SUBJECT: SYSTEMATIC ASSESSMENT OF LICENSEE PERFORMANCE (SALP)  
FOR ZIMMER AND MIDLAND

SUBJECT: Forwards affidavits attesting to corporate independence & prof qualifications of individuals who may participate in overview of const completion program.

During the meeting on March 5, 1979, you stated that on August 21, 1978, construction survey data indicated a settlement approaching the maximum value given in FSAR Figure 2.5-48. However, your response to staff request 362.12 by FSAR Revision 18 states, "In July 1978, the settlement of the diesel generator building exceeded the anticipated values shown in FSAR Figure 2.5-48." Clarify this apparent inconsistency.

FIGURE 7-1

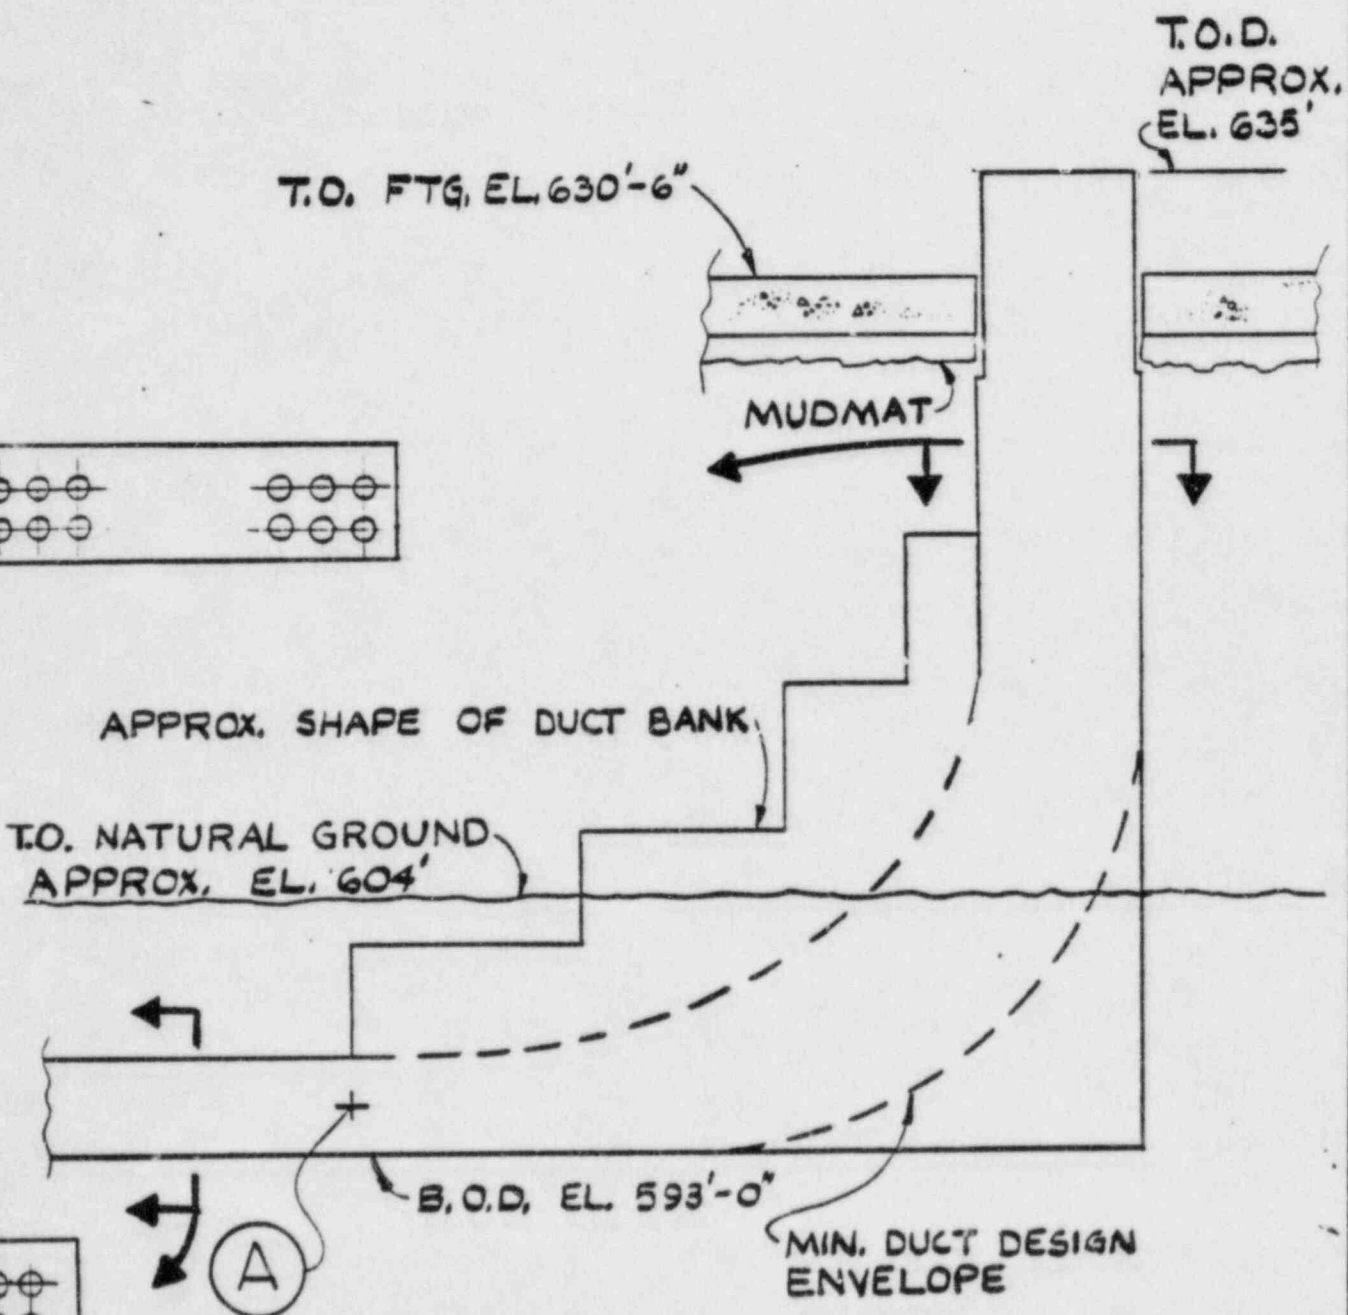
Note: Bay locations are shown in Figure 7-1.

All four duct banks were checked for continuity and obstructions after they were isolated from the diesel generator building footings. This was accomplished by pulling a segmented, hard fiber composition rabbit through each conduit (see Figure 7-3). The rabbit was pulled through the conduit by hand. No obstruction was detected during the pulling of the rabbit. The continuity check will be performed again after the preload program is completed. The results of this check, along with the results of the duct bank settlement survey, will be available after August 1979.

MIDLAND PLANT UNITS 1 & 2 CONSUMERS POWER COMPANY	
DIESEL GENERATOR BLDG SETTLEMENT DATA PEDESTAL MARKERS	
FIGURE 8-1	DATE 4 24 79

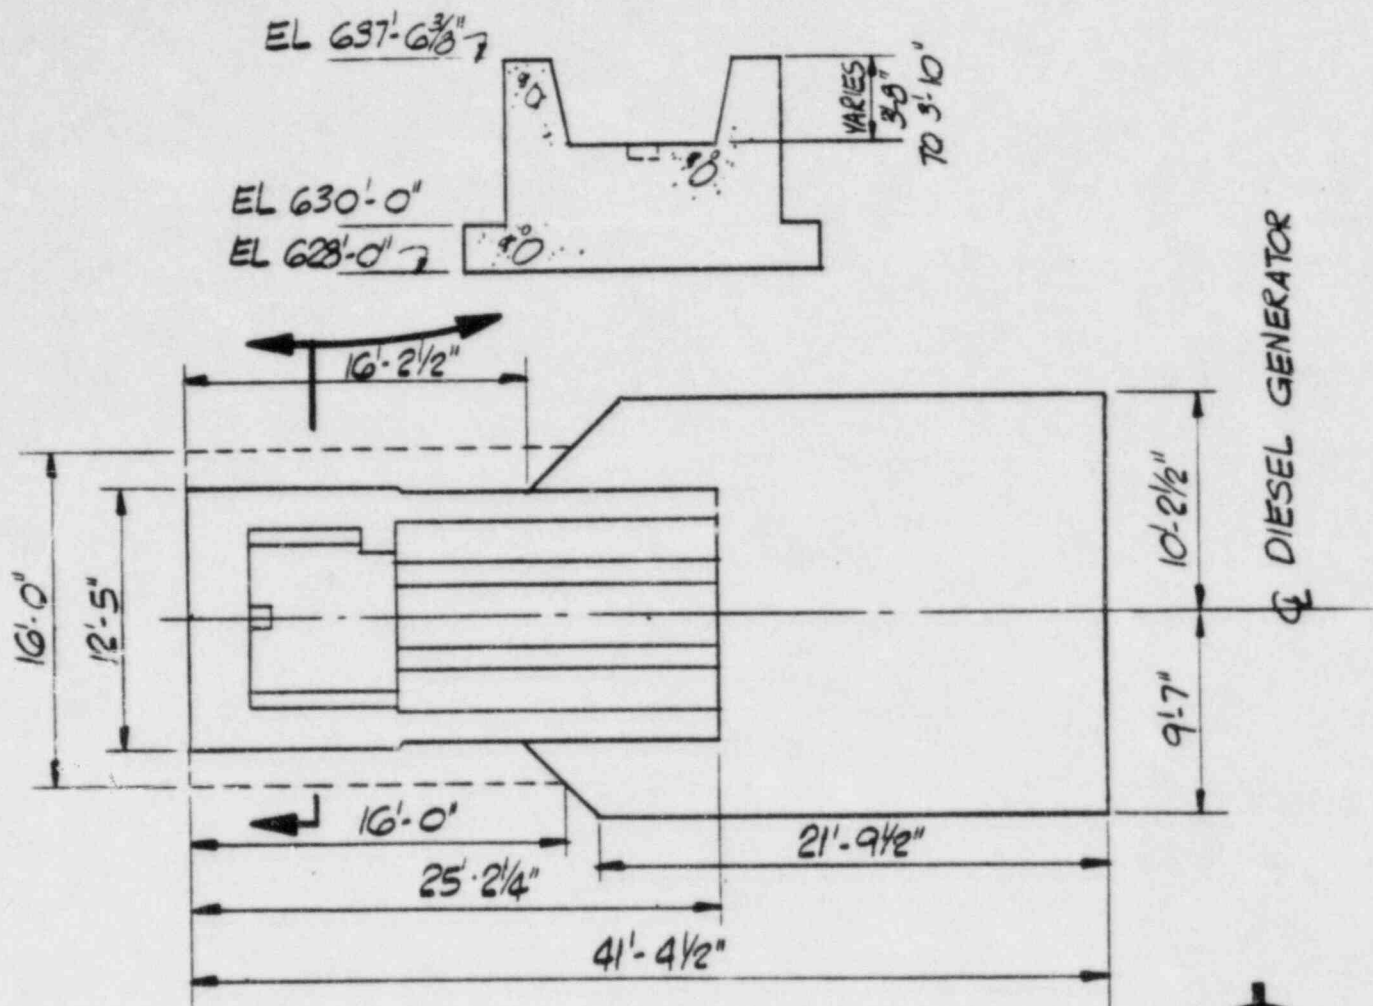
Figure 8-1 is a graphical representation of the time settlement rate of the diesel generator pedestal corners. Weekly settlement values are indicated on the chart. As of April 6, 1979, pedestal 3 had the greatest roll at 0.083 foot (.24 degree) and 0.068 foot (.31 degree). Figure 8-3 identifies settlement values at their respective corners along with tilt and roll.

MIDLAND PLANT UNITS 1 & 2 CONSUMERS POWER COMPANY	
DIESEL GENERATOR BLDG PLAN & SECTIONS	
FIGURE 13-9	DATE: 4/24/79

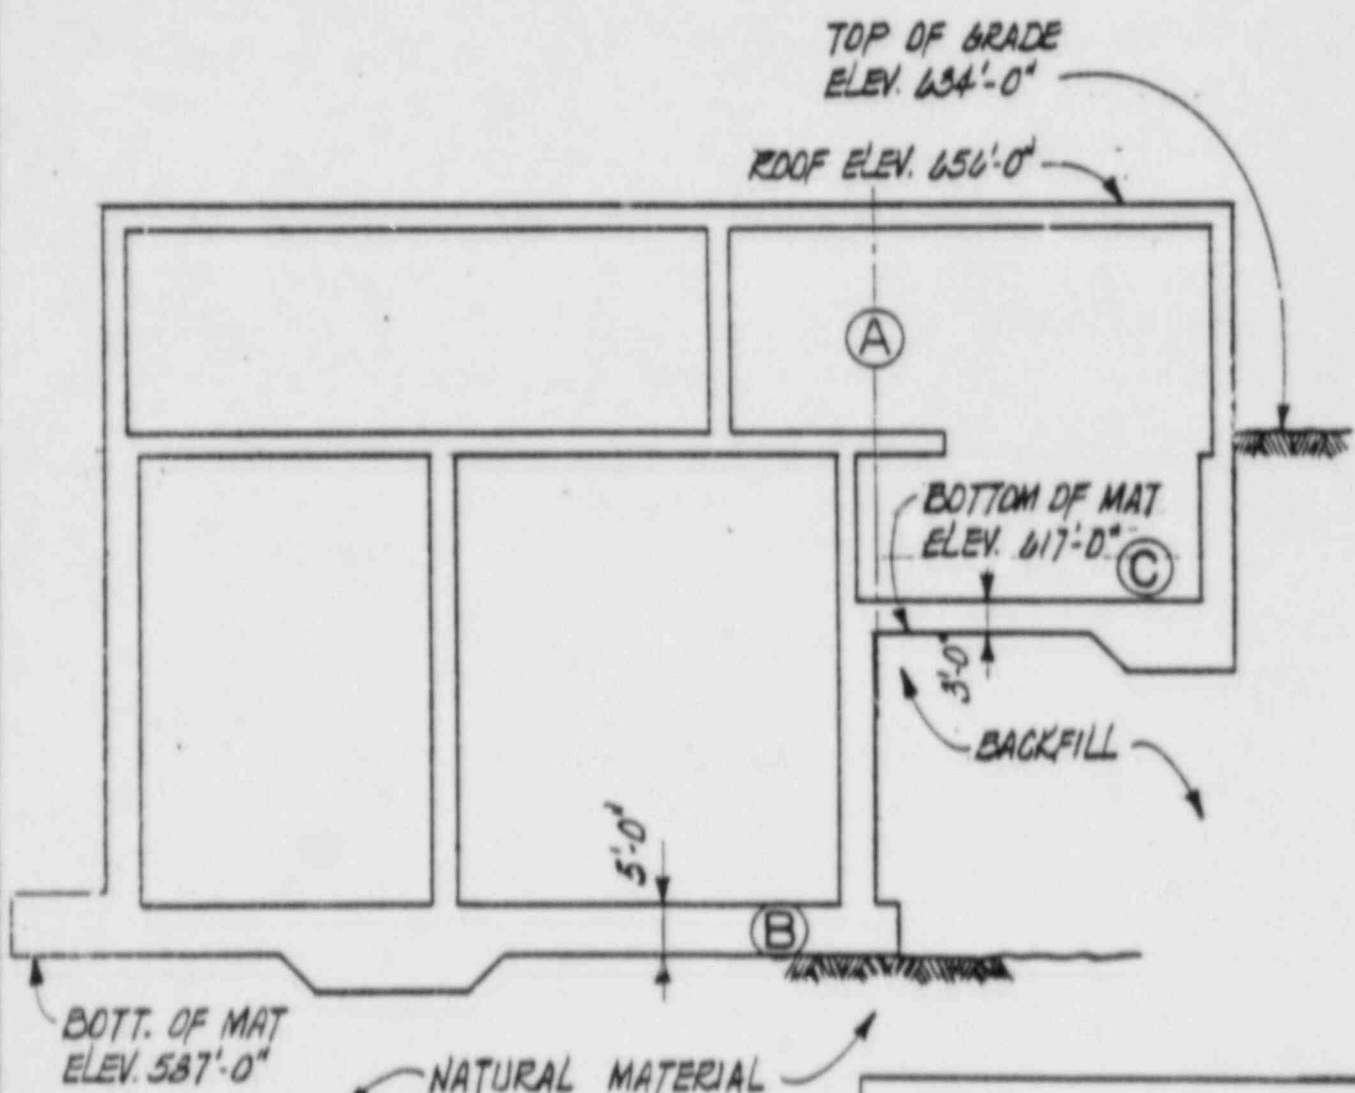
#### 1) Diesel Generator Building (See Figure 13-9)

MIDLAND PLANT UNITS 1 & 2 CONSUMERS POWER COMPANY	
SERVICE WATER STRUCTURE TYPICAL SECTION	
FIGURE 13-10	DATE: 4/24/79

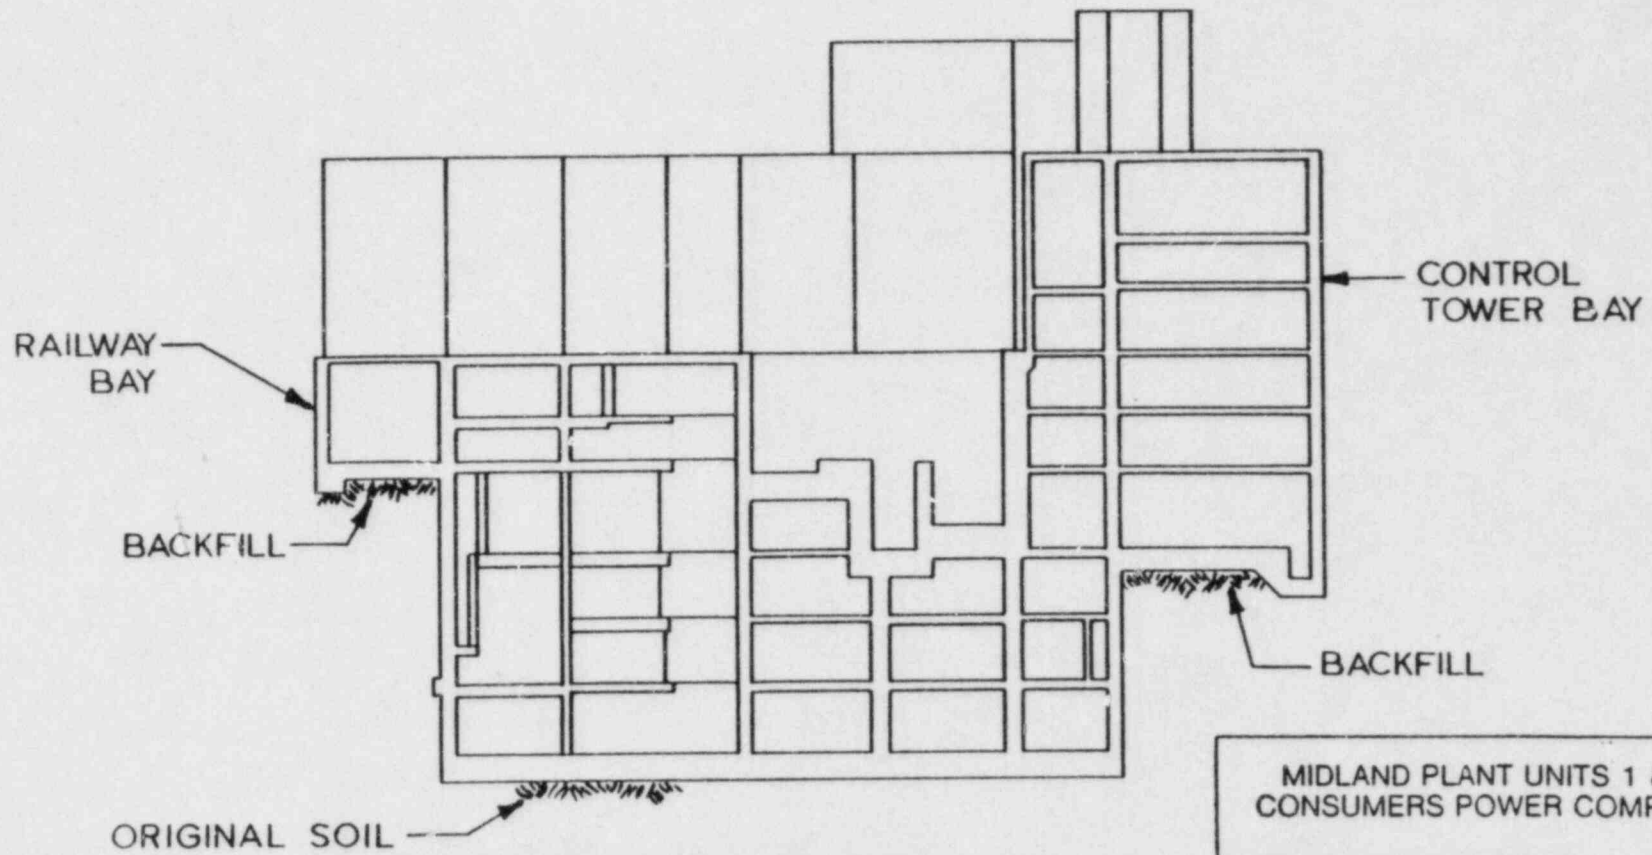
2) Service Water Pump Structure (see Figure 13-10)

MIDLAND PLANT UNITS 1 & 2 CONSUMERS POWER COMPANY	
AUXILIARY BLDG TYPICAL SECTION	
FIGURE 13-11	DATE: 4/24/79

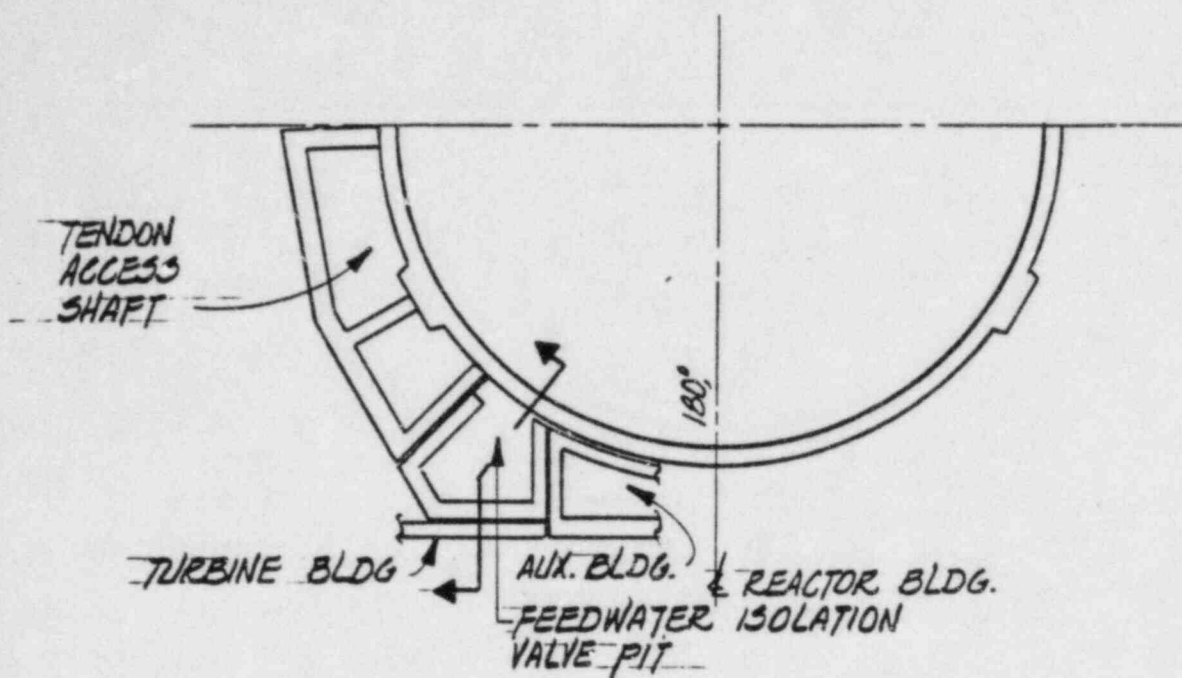
3) Auxiliary Building (see Figure 13-11)
